PUBLIC NOTICE
WOODLAND PARK PLANNING COMMISSION
Thursday, April 13, 2023, 6:30 P.M.
Council Chambers – 220 W. South Avenue
REVISED AGENDA

Planning Commission Staff Report Public Hearing April 13, 2023

#CUP2023-01 A request by Mountain Starr Investments, LLC. (Property Owner) and Creighton Soukup (Applicant) to approve an amendment to a conditional use permit and site plan to allow 8 apartment buildings with 122 attached multi-family dwellings units in the Multi-Family Residential Urban (MFU) zone. The subject property is a 7 acre parcel located at the end of Tamarac Parkway and is known as Lot 6 Tamarac Tech Park Filing No. 5, City of Woodland Park, Teller County, Colorado (**QJ**)

Figure 5b: Building Type A elevation

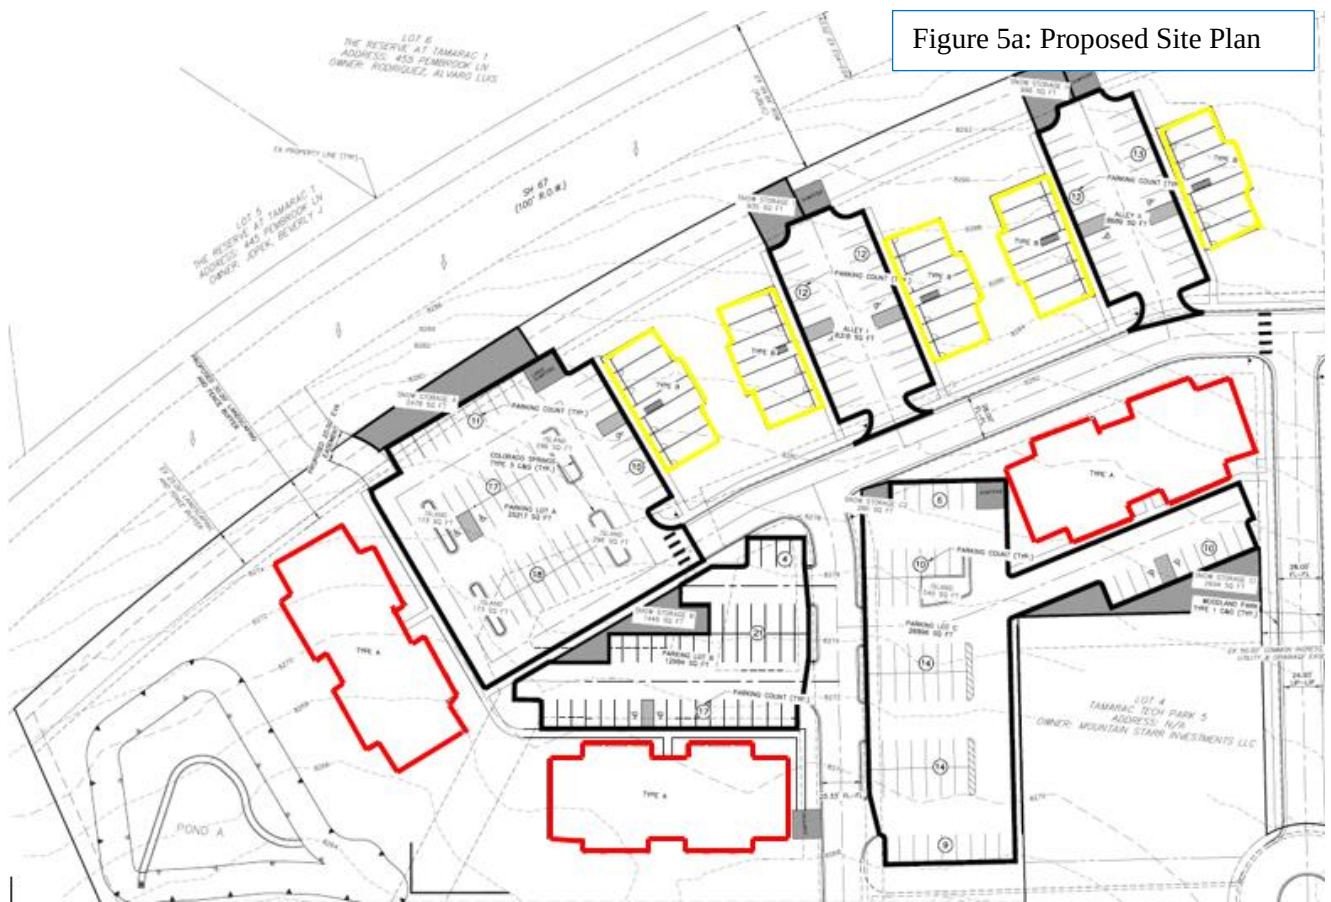
May Comply. Staff has concerns with the design of the Type A buildings and will be requesting additional design modifications so the structure will better harmonize with the Woodland Park aesthetic. The application may comply if the applicant adheres to the City's architectural design standards.

May Comply. Staff has concerns with the design of the Type A buildings and will be requesting additional design modifications so the structure will better harmonize with the Woodland Park aesthetic. The application may comply if the applicant adheres to the City's architectural design standards.

- ix. CO Stormwater Permit/Stormwater Management Plan
2. Coordinate with staff to modify the "Type A" building façade to better harmonize with the Woodland Park "mountain western" aesthetic.

PRELIMINARY GRADING PLAN
LOT 6 TAMARAC TECH PARK FILING NO. 5
JOB NO. 25199.01
03/07/23
SHEET 3 OF 5

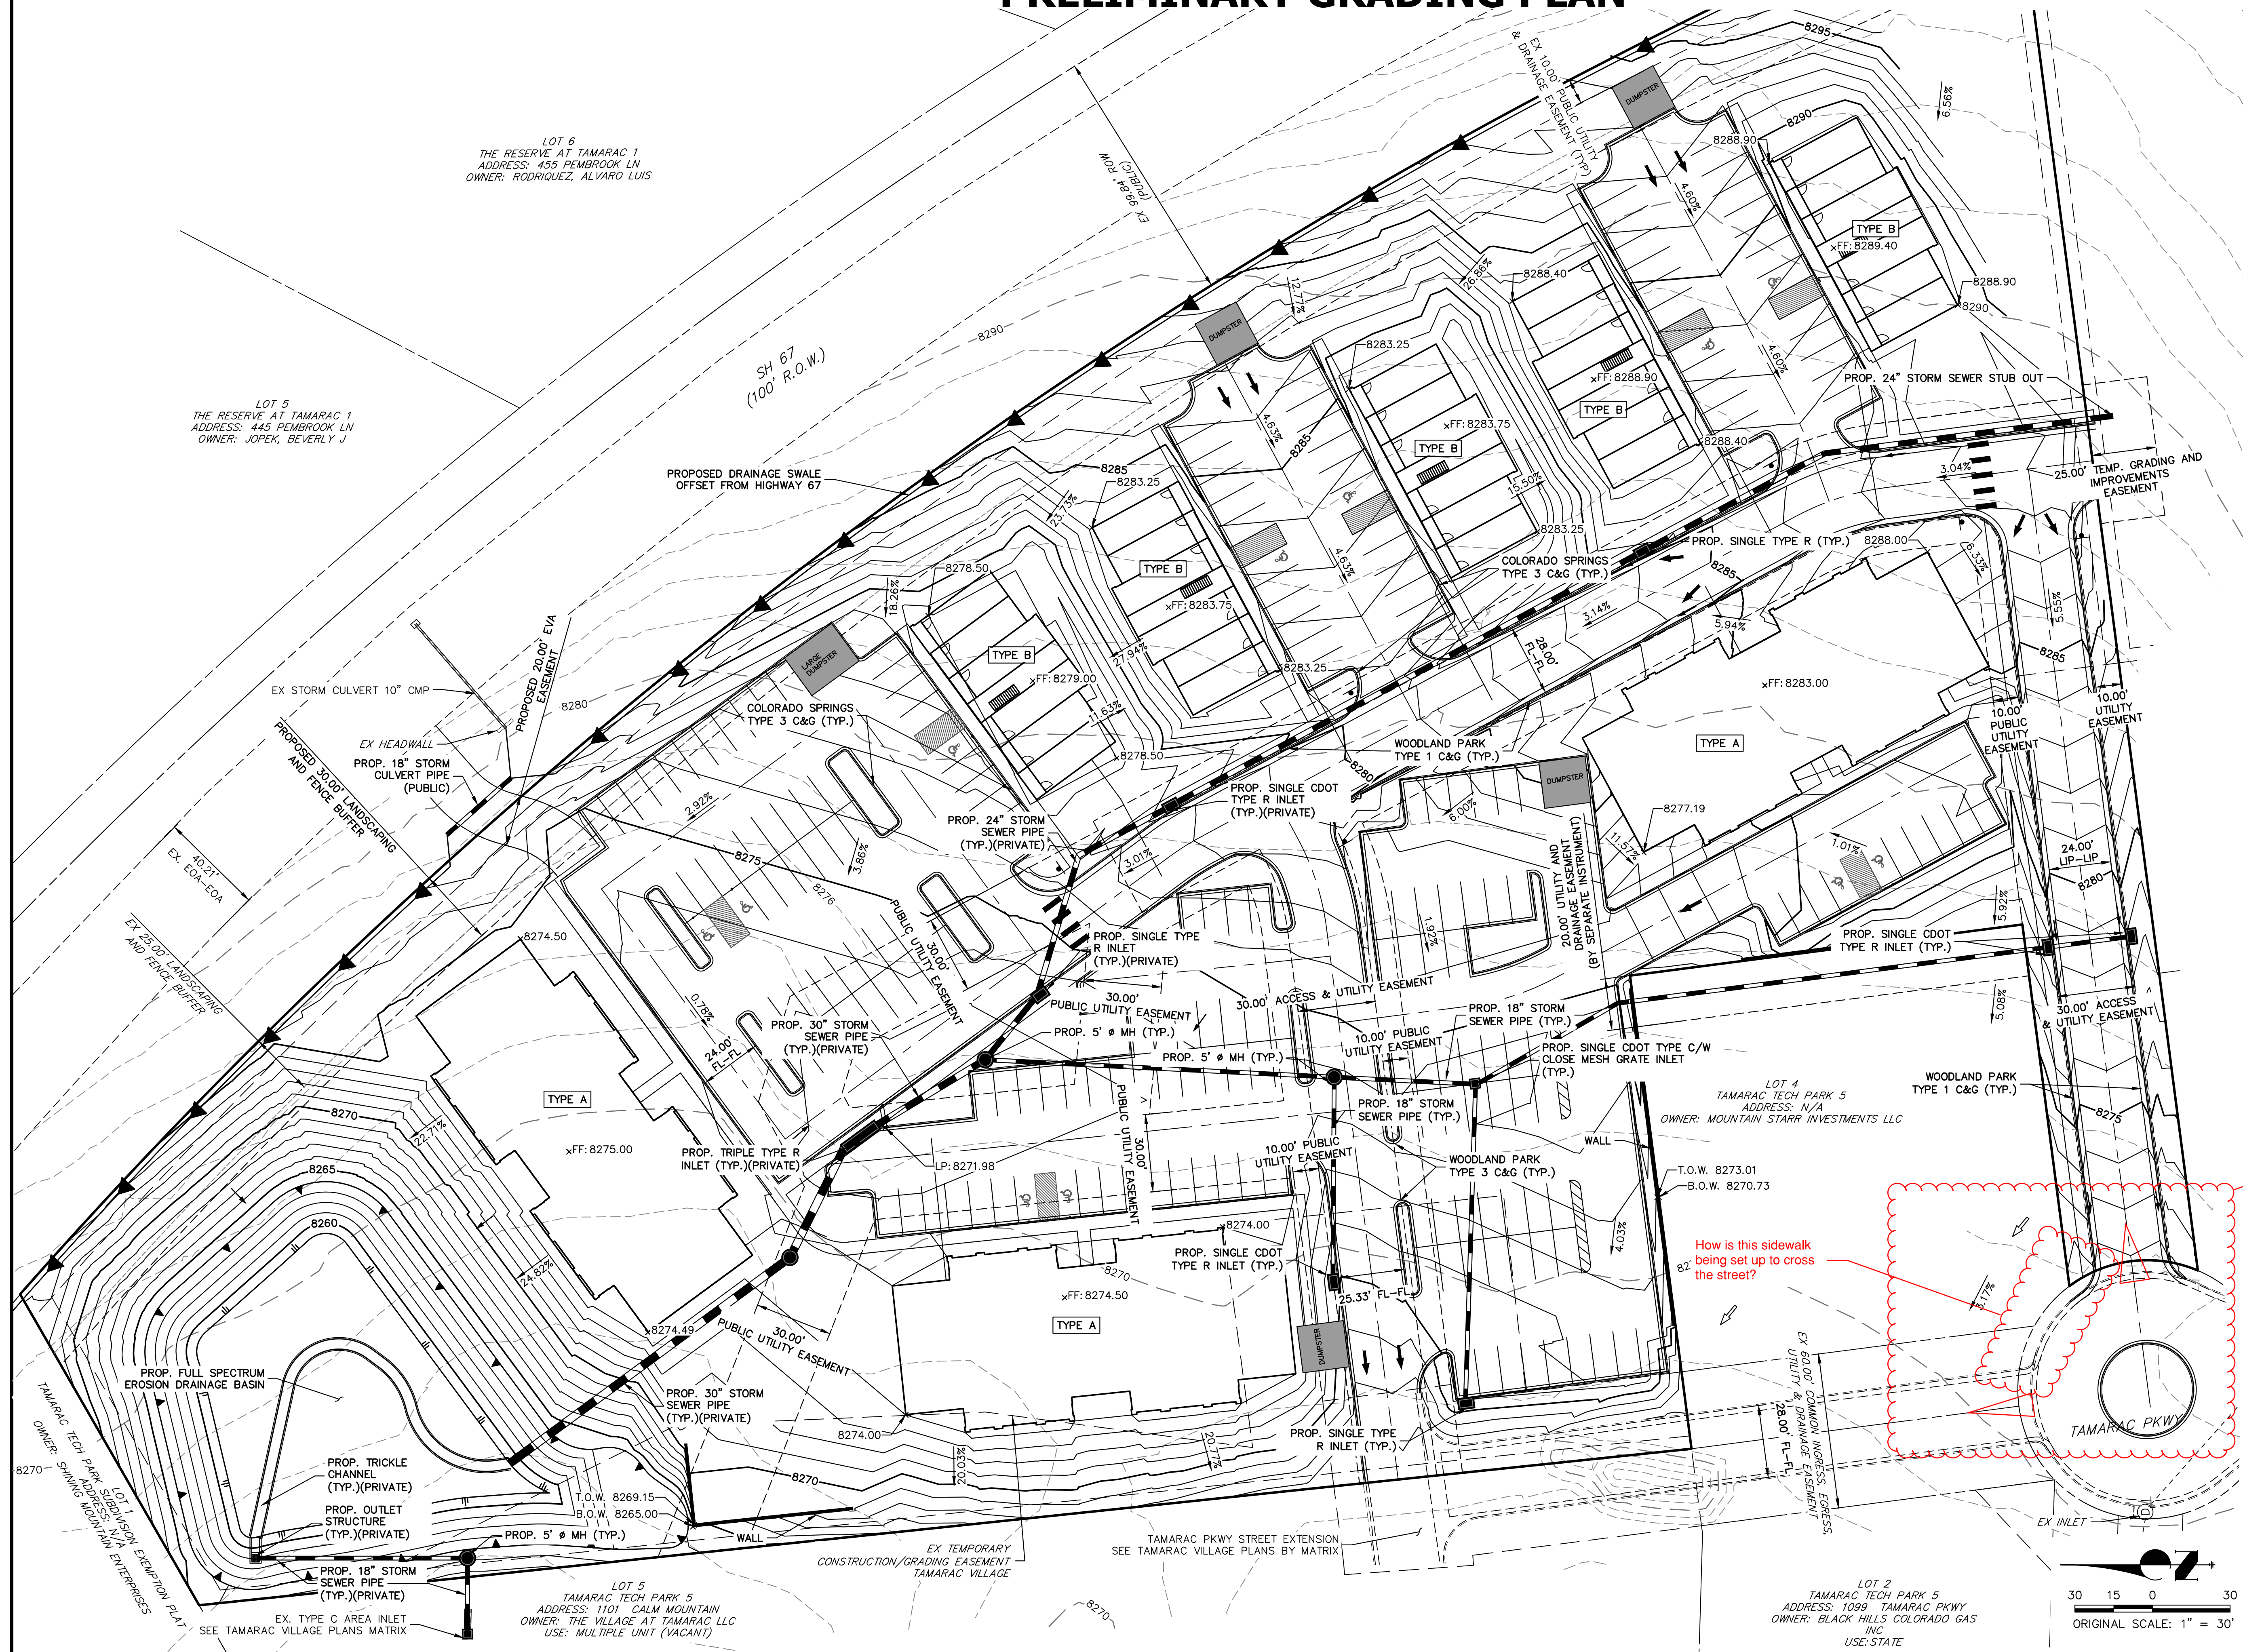
please detail striping,
ped crossings, and
intersection/median
controls to channelize
vehicles into traffic
circle

PRELIMINARY UTILITY PLAN
LOT 6 TAMARAC TECH PARK FILING NO. 5
JOB NO. 25199.01
03/07/23
SHEET 4 OF 5

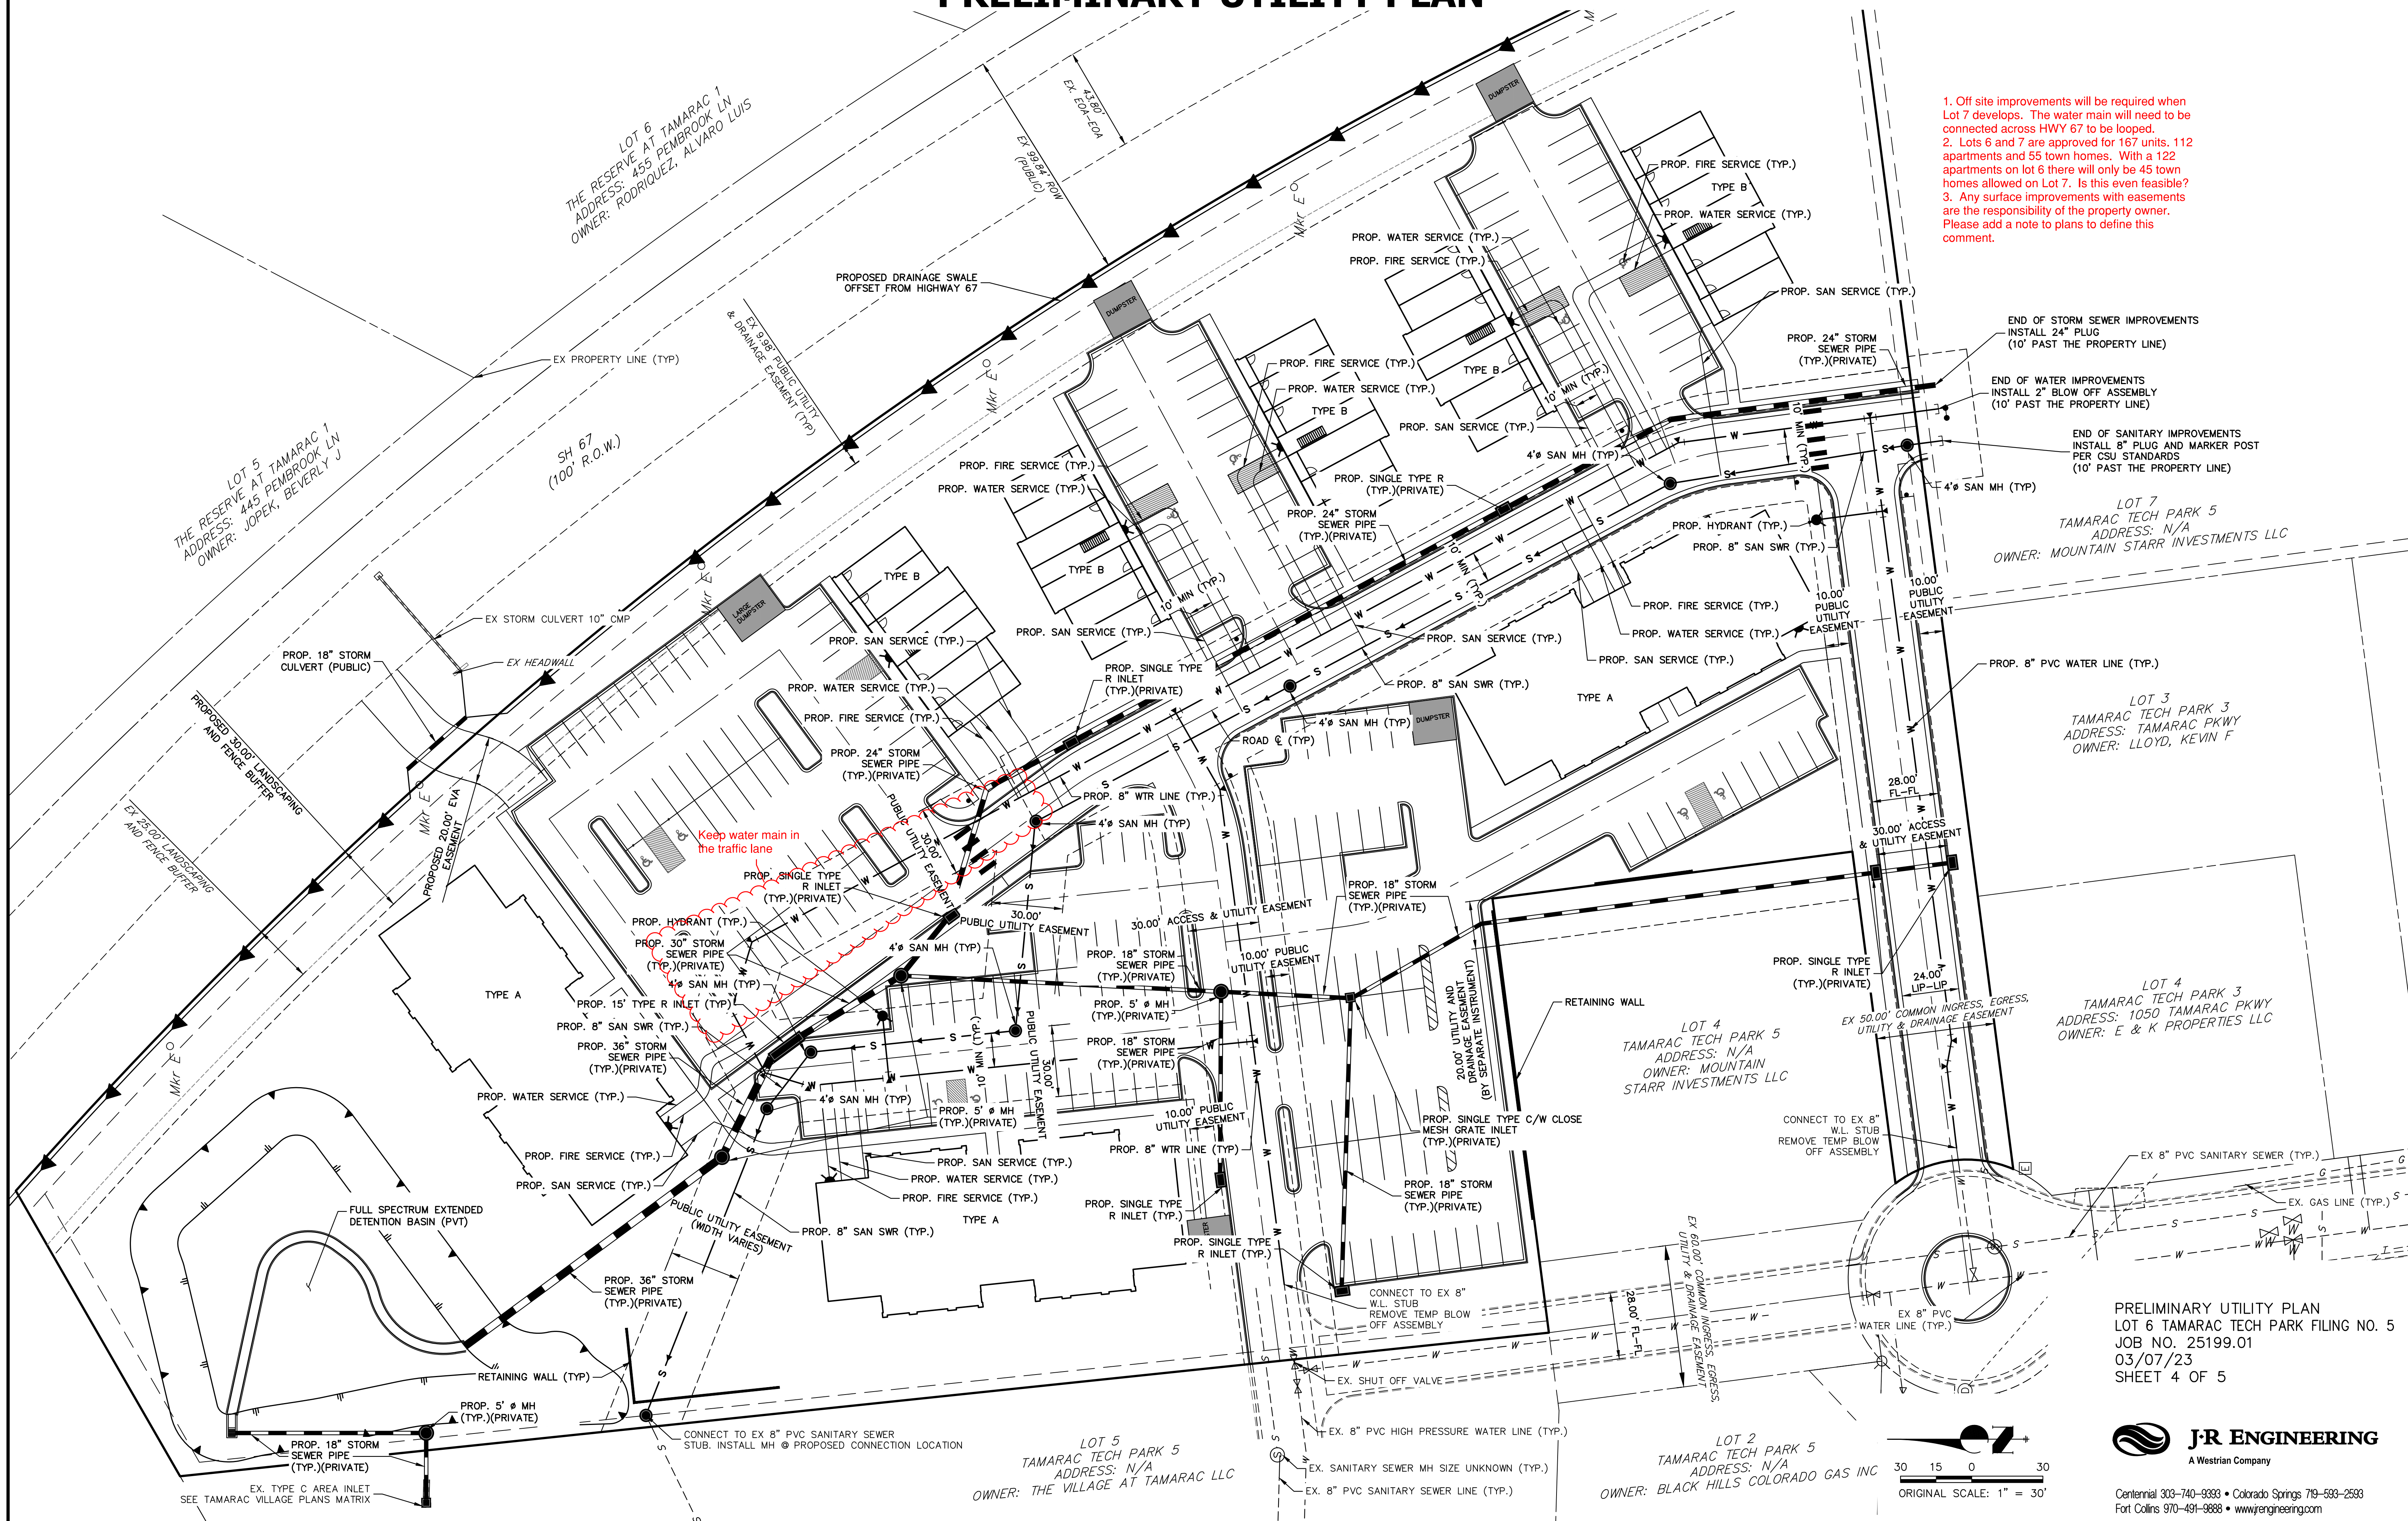
- 1. Off site improvements will be required when Lot 7 develops. The water main will need to be connected across HWY 67 to be looped.
- 2. Lots 6 and 7 are approved for 167 units, 112 apartments and 55 town homes. With a 122 apartments on lot 6 there will only be 45 town homes allowed on Lot 7. Is this even feasible?
- 3. Any surface improvements with easements are the responsibility of the property owner. Please add a note to plans to define this comment.

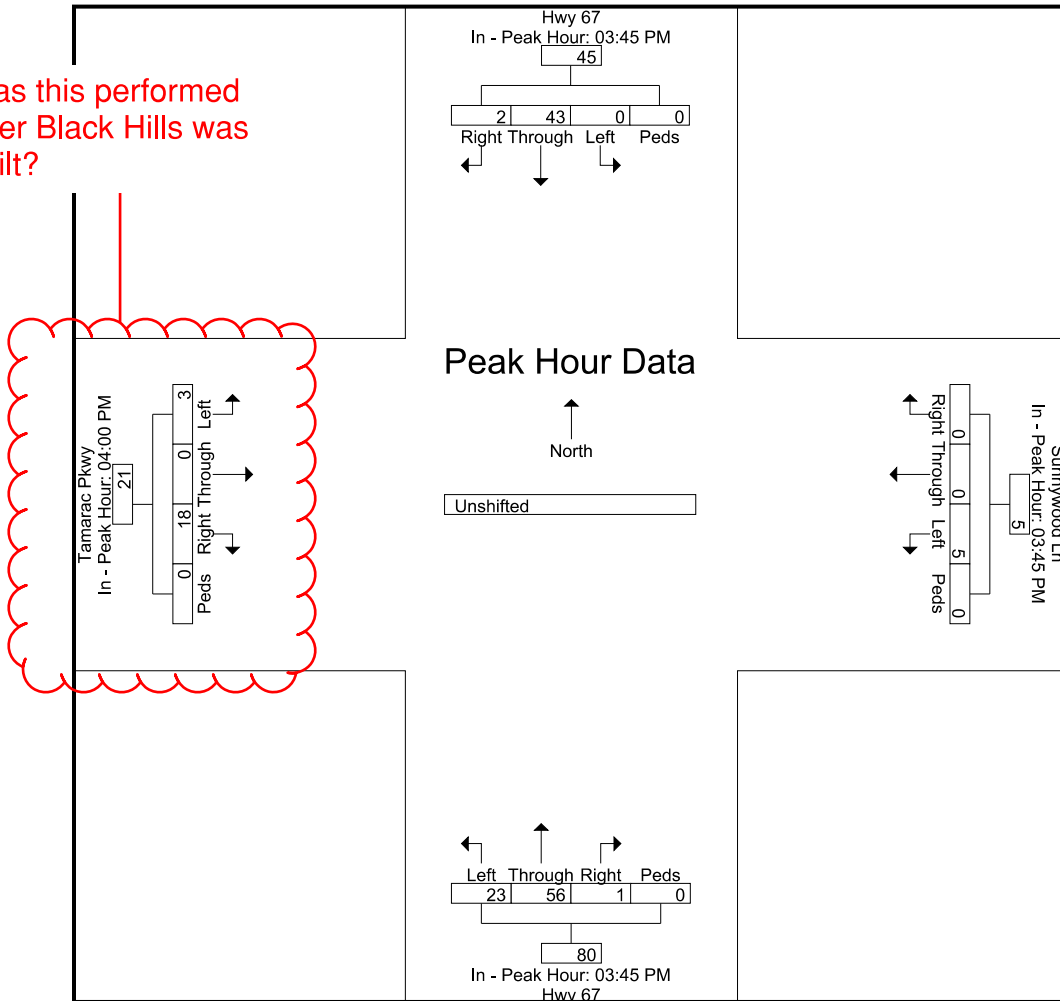
Was this performed
after Black Hills was
built?
